Electronic Pressure Relief Valve (EPRV) Delete & Fuel Rail Pressure Sensor Update

Model Years	Models
2018 - 2020	AN/CHU/CXU/GR/GI/PI/MRU/LR/TE

EPRV Delete & FRPS Update

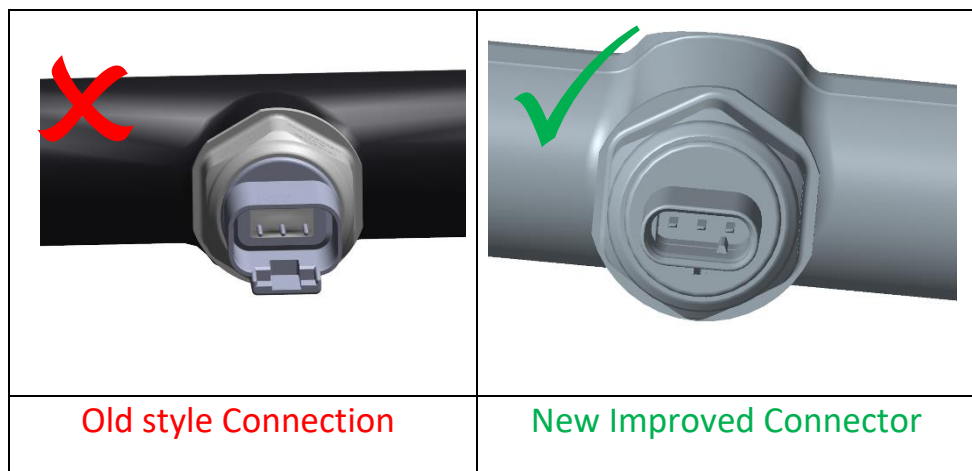
17. A product improvement has been made to the Fuel Rail Pressure Sensor (FRPS) and its wiring harness. A visual inspection of the FRPS electrical connector will indicate which sensor and wiring harness is on the vehicle

18. Inspect the FRPS, if the Old Style Connector is found (Displayed above with red X), replace the sensor and wiring harness per Impact Instructions listed below. If the New Improved Connector is found, no farther action is needed and proceed to next step.
 - a. 2373-03-03-06 Pressure Sensor, Common Rail, Replacement, Valve Cover Removed
 - b. 2861-03-03-03 Wiring Harness, Injector, Replacement (Rear), Valve Cover Removed
19. Refer to IMPACT document ID: 2115-03-02-02 *Valve Cover, Replacement* for valve cover install procedure.
20. Using PTT Operation 1700-22-03-06 Program accessory kit: **85156014**
Note: Running this kit without removing the ePRV will result in adverse vehicle affects.
